Work Order ID: 88371

Item Name: Fuel Purge Canister

DART SERVICE INSTRUCTION

TO AMEND INSTALLATION INSTRUCTIONS IIN-D412-706 REV. A AND ICA-D412-706 REV. 0

FIGURE 1. CANISTER ASSEMBLY
(-011 INSTALLATION AT CHG 002)

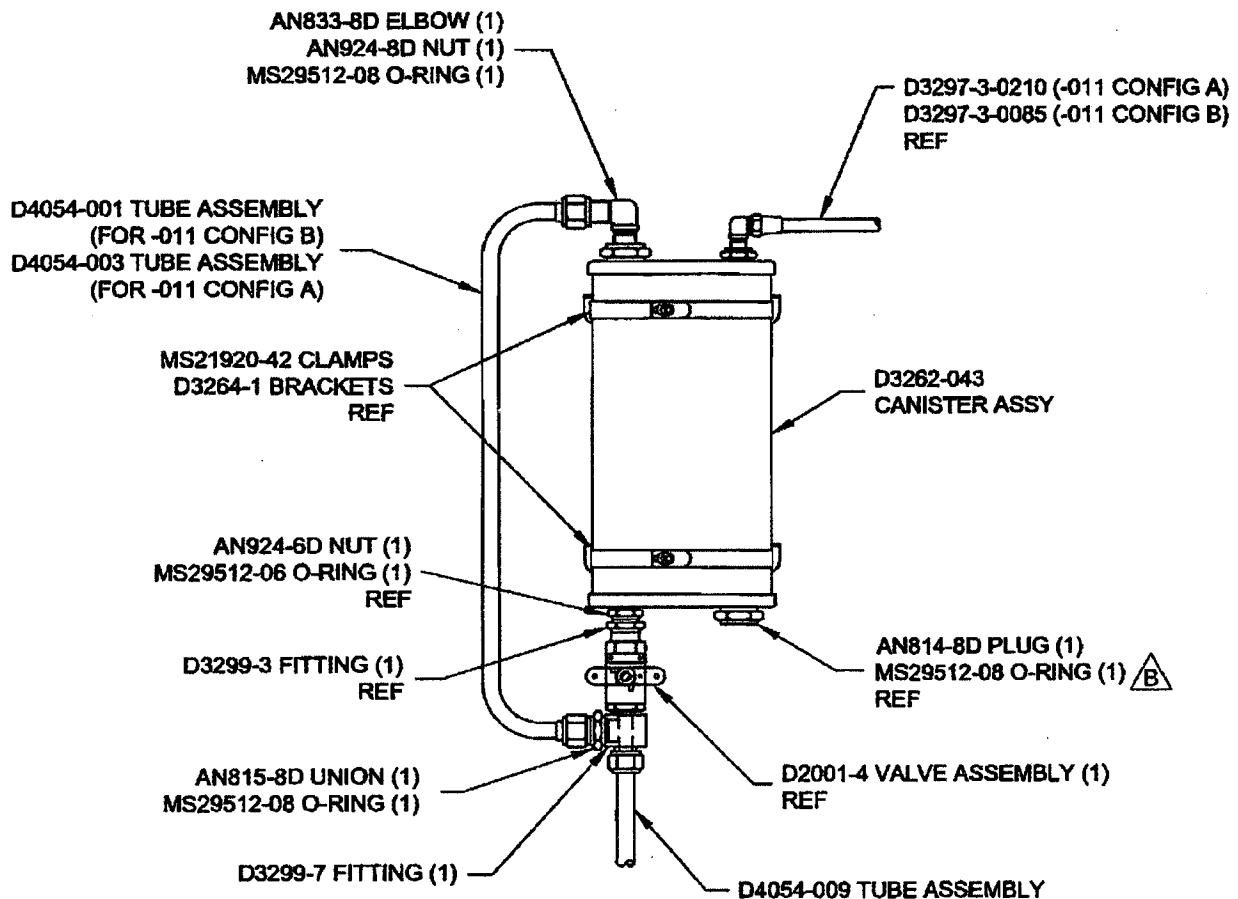
AT CHG 002, THE D412-706-011 FUEL PURGE CANISTER INSTALLATION HAS BEEN MODIFIED WITH LARGER VENT LINES TO ELIMINATE BACK PRESSURE THAT MAY OCCUR WHEN STARTING THE SECOND ENGINE IF THE CANISTER HAS NOT BEEN PROPERLY DRAINED. THE BACK PRESSURE IS EVIDENCED BY AN ONGOING VAPOR DISCHARGE FROM THE CANISTER VENT AT LOW TO MEDIUM RPM WHILE STARTING THE 2nd ENGINE. THE UPDATED PARTS LIST IS SHOWN BELOW:

$\triangle B$ NOTE: FOR THE LARGER D4054-009 LINE, CUSTOMER MUST DRILL A $\varnothing 0.813$ HOLE AND INSTALL MS35489-16 GROMMET INSTEAD OF MS35489-11 GROMMET IN BELLY SKIN.
